N5230A-06A

S E R V I C E N O T E

N5230A PNA-L Series RF Network Analyzers

Add-on mechanical components to enhance instrument reliability

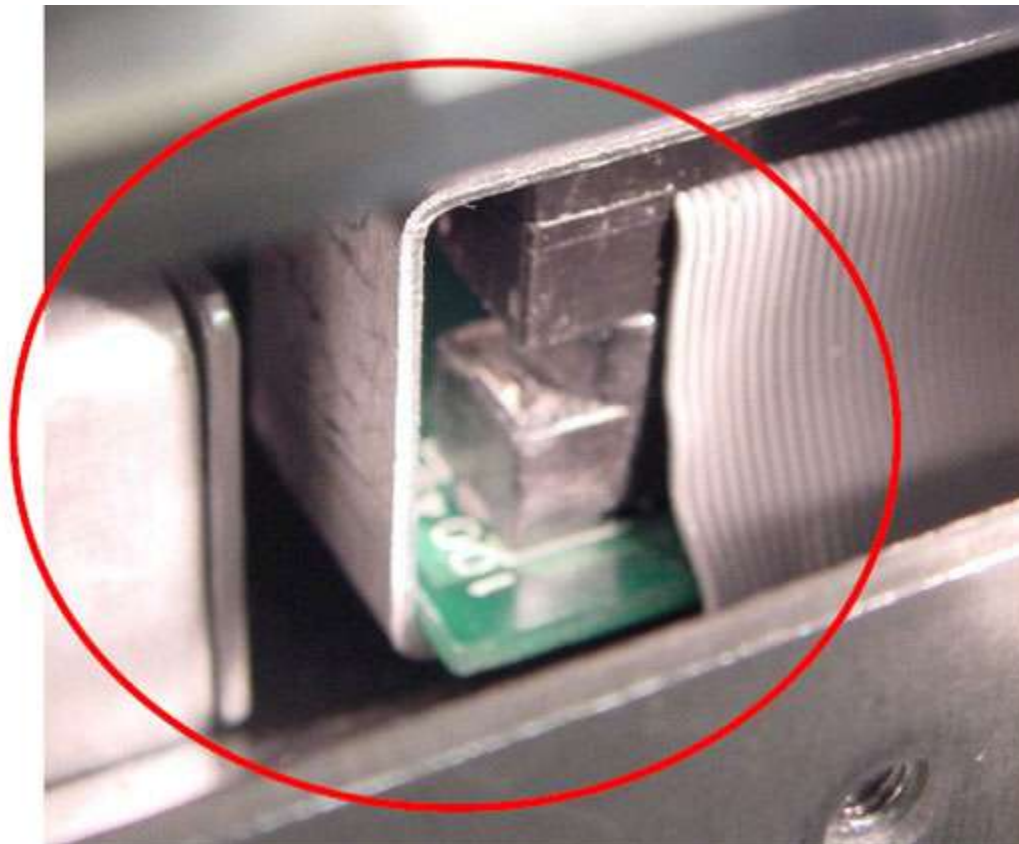
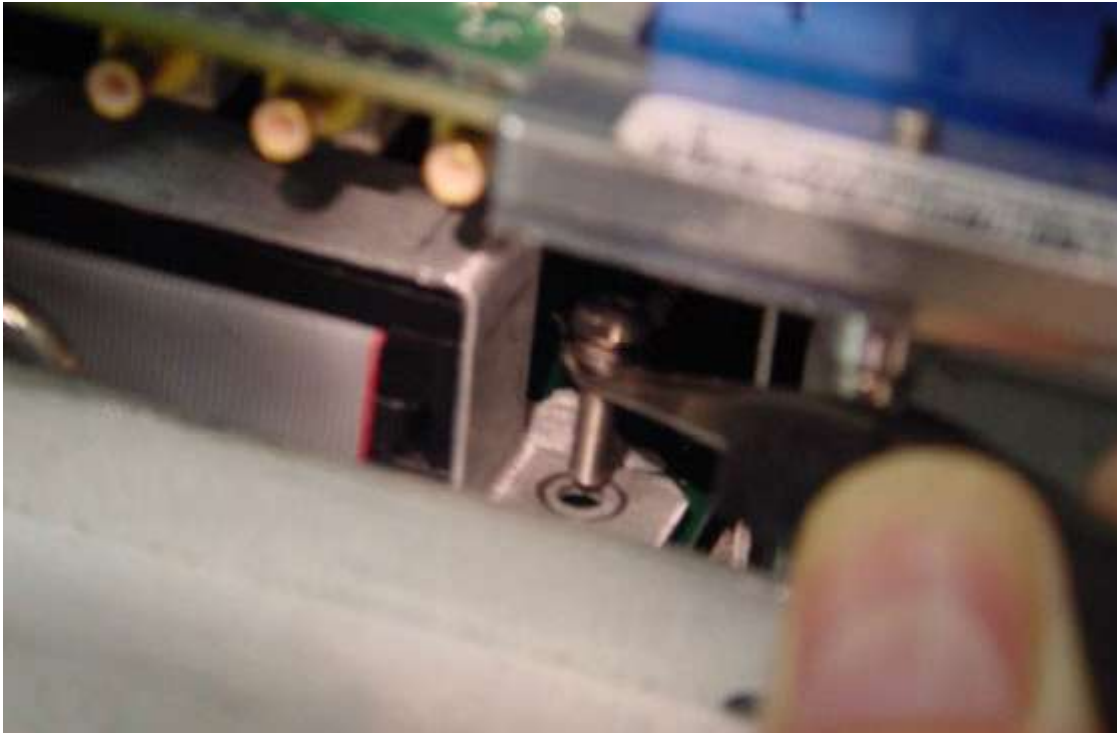
- a. Remove and discard existing screw near ribbon cable connector on System Motherboard. See below.

- b. Insert Ribbon Cable Clamp under Source Assembly as shown.

- c. Position the clamp over the Ribbon Connector. Use needle nose pliers if necessary to slide the clamp into place. Ensure that the edge of the clamp is parallel to the connector and not skewed.

NOTE: Ensure that the Clamp Lip is secured BELOW the edge of the System Motherboard

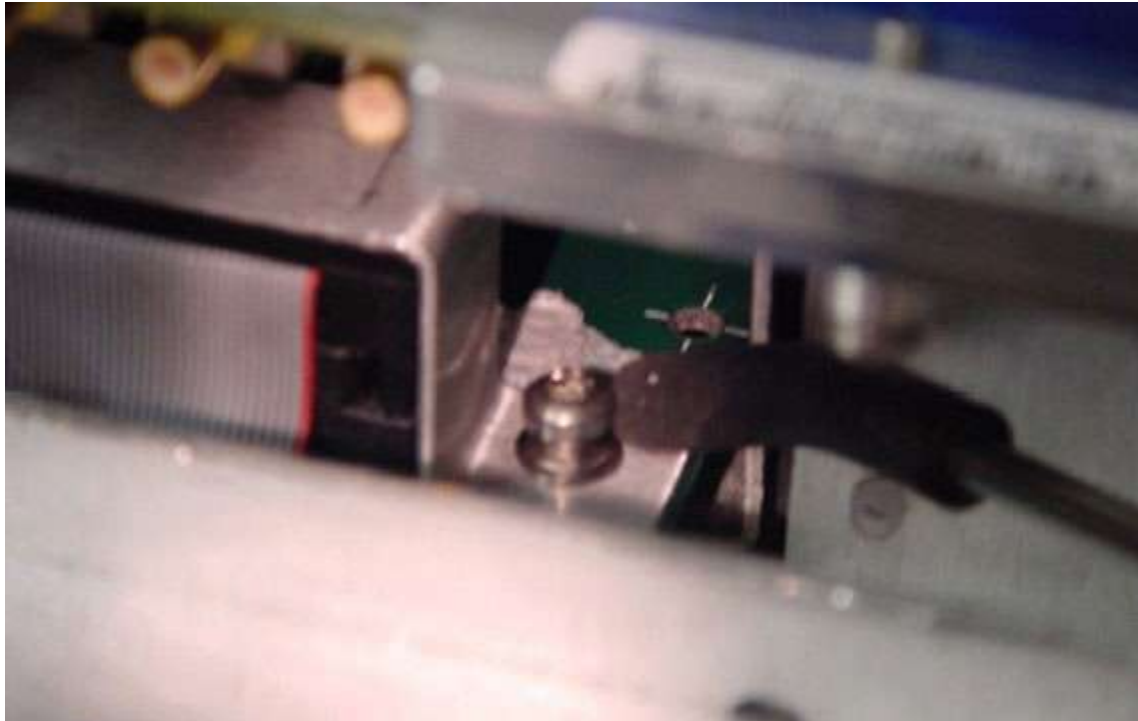
- d. Using tweezers, install a new 0515-0374 screw through the hole in the bracket.

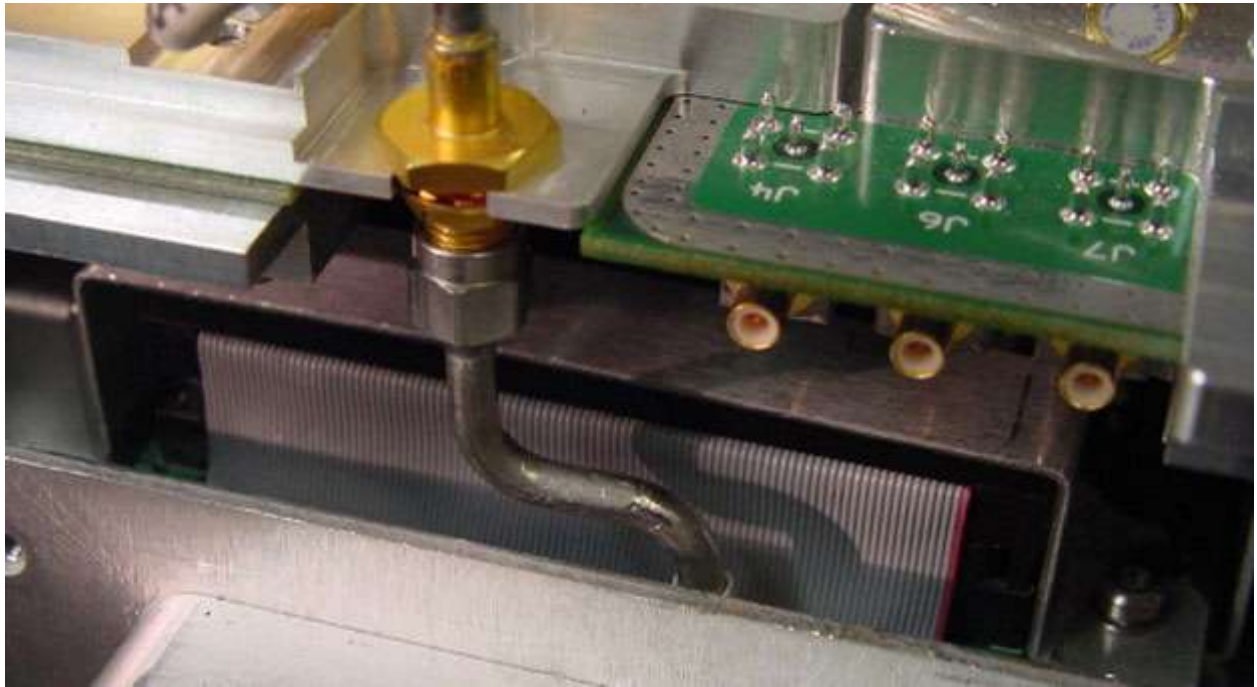
g. This image shows the final position of the secured clamp.

Figure 1:
Clip Retainer (E8361-20067)
And
Flat Head Screw (0515-1644)

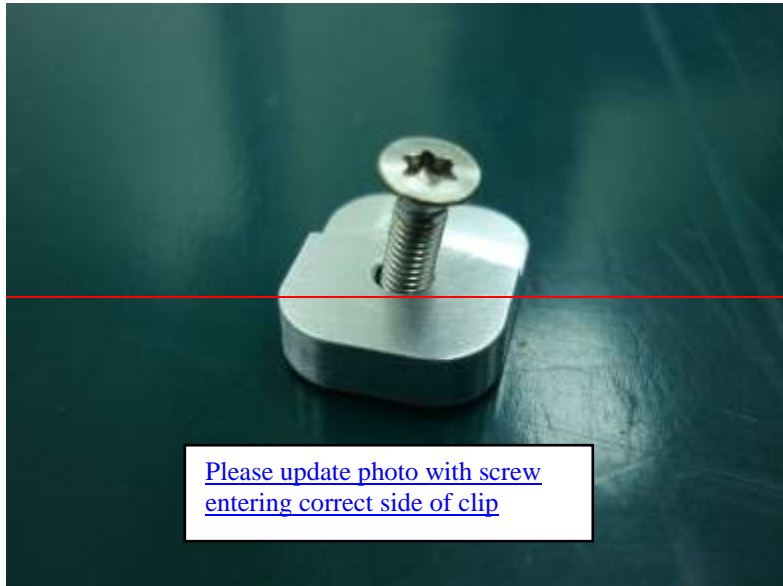
The Clip Retainer (E8361-20067) to be secured with Flat Head screw (0515-1644) in 2 places at 9 lb-in. This Retainer Clip may naturally rotate a bit when being secured, which is acceptable. Note that the existing screw needs to be removed and discarded prior installing Retainer Clip #1 (shown below in Figure 2a, 2b and 3). The final replacement out is as shown in Figure 3.

Figure 2a

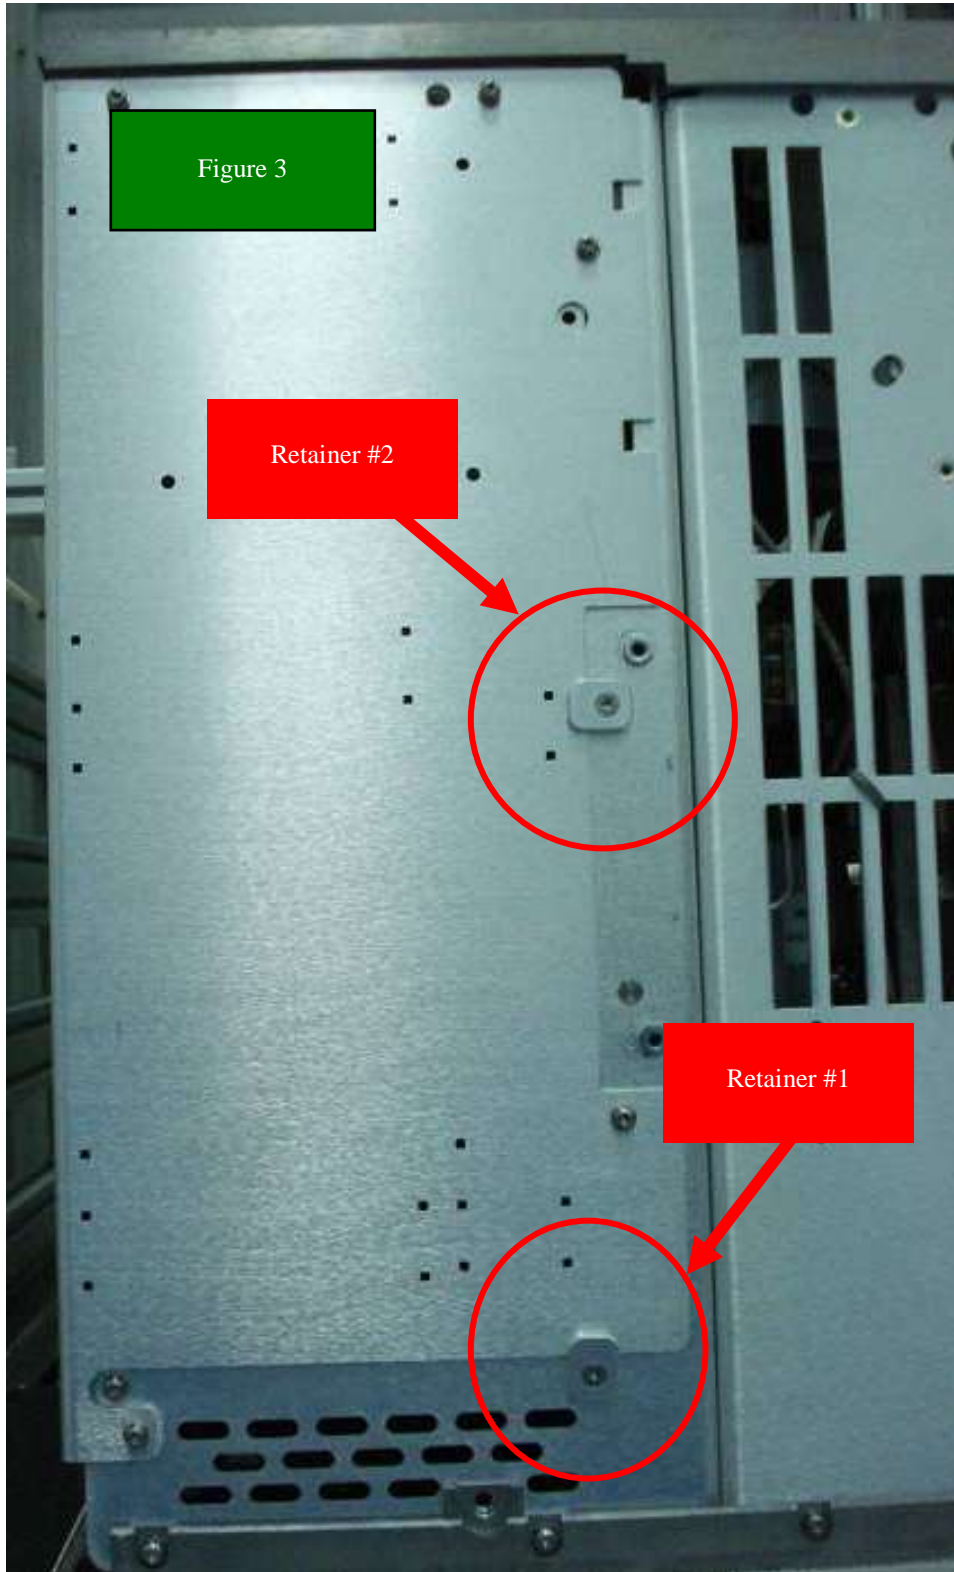
[Please update photo with screw entering correct side of clip](#)
